## 16-125 LOWER FRAME CROSS BRACES – FIELD BULLETIN

| <b>MODEL</b>      | 16-125                                                                              |
| <b>DETAILS</b>    | Lower frames may have incorrect tab locations; different cross braces are required. |

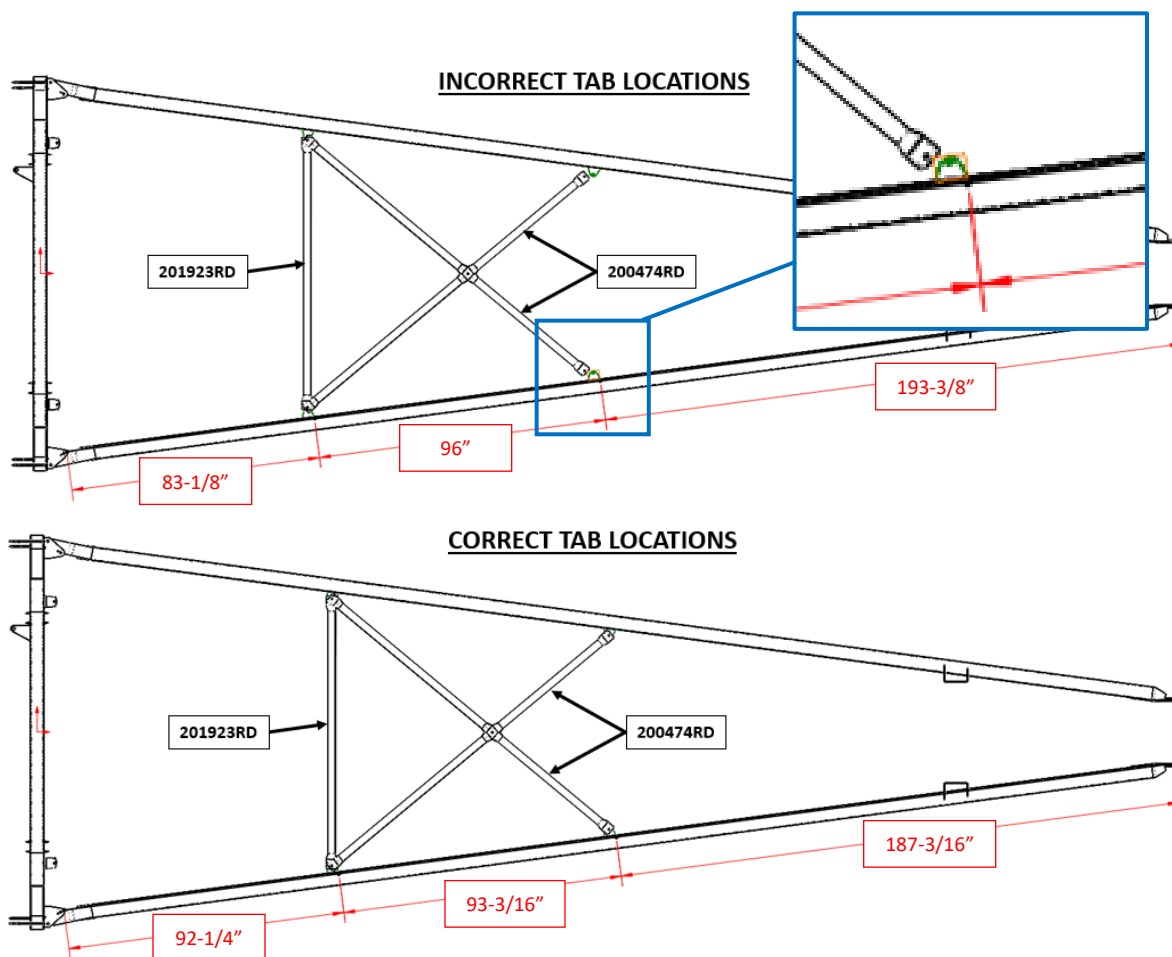
Measure and compare the frames you receive to the drawings above. If you did receive lower frames with the incorrect tab locations, we will be sending you different cross braces. The bundle you require is 203474RD, which consists of are 1 x 203472 (Lower Tie Brace), and 2 x 203473 (Lower X-Brace). We are currently in the process of sending these cross braces out.
